October 19, 2006

**Re: Centredale Manor Restoration Project Superfund Site,
 North Providence, Rhode Island**

On behalf of Emhart Industries, Inc. ("Emhart"), we are submitting for inclusion in the administrative record for the above-referenced site comments on the Interim-Final Baseline Human Health Risk Assessment (Aug. 2004; revised Nov. 2005) ("BHHRA"), Interim-Final Baseline Ecological Risk Assessment (Sept. 2004) ("BERA"), Interim-Final Remedial Investigation Report (Jun. 2005) ("RI Report"), and Interim-Final Preliminary Remediation Goals Report ("PRG Report") for the Centredale Manor Restoration Project Superfund Site ("Site"). Emhart respectfully requests that EPA withdraw these decision documents and correct the errors set forth therein, as discussed in this letter and in the enclosed comments.

Figure 3: Plots of HCX (Red) and HxCDD (Blue) ions' intensity vs. mass/charge ratio at nominal $m/z = 388$ assuming a Gaussian peak shape and a resolving power of 10,000.

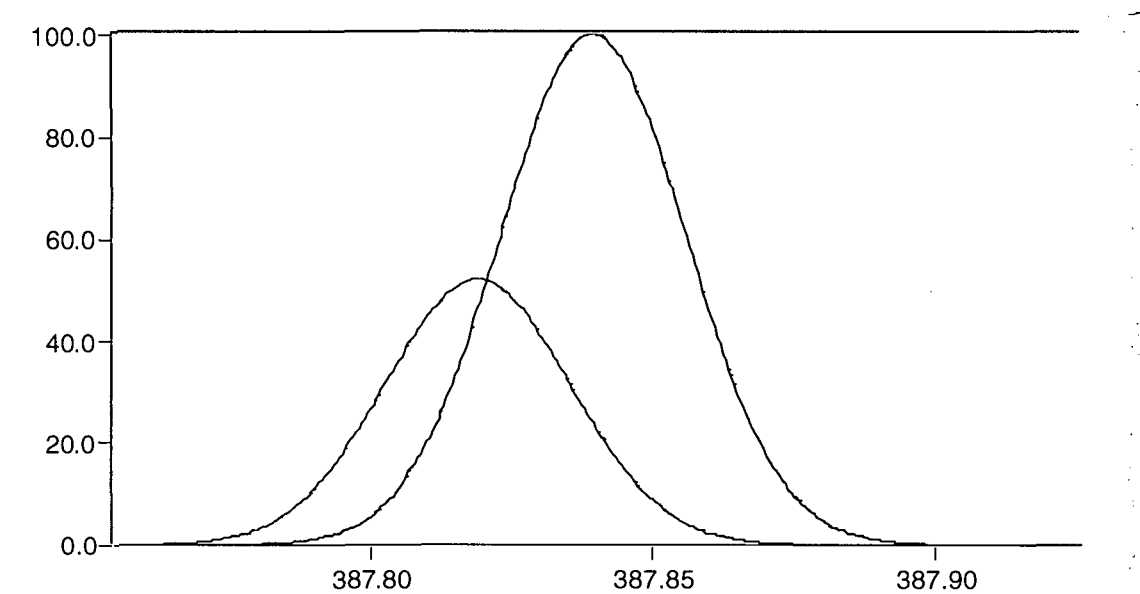
The authors seem not to realize that the SIM (Selected Ion Monitoring) experiment would lead to an approximately 100-fold improvement in signal:noise ratio compared to the full scan analysis if they had properly entered the correct exact masses into the SIM descriptor.

The point can be readily understood by inspection of the peak positions and shapes for HCX and the HxCDD (hexachlorodibenzo-p-dioxin) ions discussed above:

The peaks are poorly resolved so that monitoring for HxCDD would result in interference from HCX, as is reported. The concern is raised from the scanned mass spectrum that resulted in ion m/z 's that failed to give a response in the subsequent selected ion monitoring experiment. I am aware of no explanation other than an error in the mass measurement or an error in editing the SIM descriptor to explain the authors' observation. Did the measured m/z agree with the calculated m/z for the elemental composition of HCX or not? If so, HCX should have been observed in the SIM experiment. If not, the compound is not HCX. Properly operated, the required mass measurement accuracy is well within the specifications of the equipment used for these measurements. The appropriate action at this point would have been to find and correct the problem with the mass measurements and/or structural assignment for the HCX reference standard.
